Technical Bulletin

Model
All 1993

Subject: New Version Wheel Locks

Number
9304

Figure 1

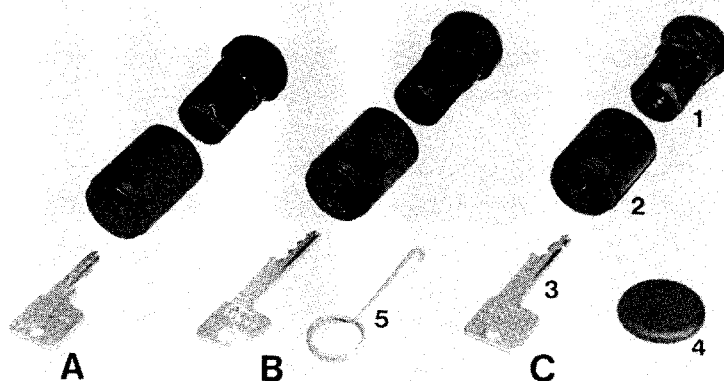
Concern: A new wheel lock is available which is 15mm shorter and is 7 grams less in weight than previous versions.

General Information: The new wheel lock has been installed in production as of August 17, 1992. The new lock is closer in appearance and weight to the standard lug nuts. With the introduction of this lock, the tool for removal of the protective cap has been eliminated (see Figure 1, Number 5). Removal of the protective cap is done by using the lock key which is supplied with the lock set. There is a notch cut into the key which is used for removal of the protective cap (see Figure 2).

Figure 3

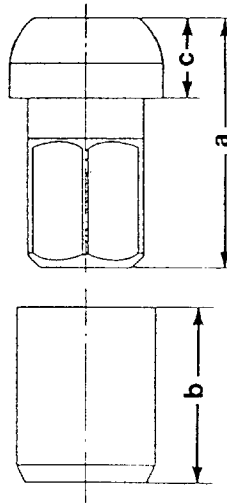
Part Identification:
(See Figure 3)

The following illustration will help to identify the version wheel lock should it become necessary to do so.

Version	Dimension		
	a	b	c
A	40.0mm	33.5mm	10.5mm
B	43.5mm	33.5mm	12.5mm
C	38.5mm	29.5mm	9.0mm
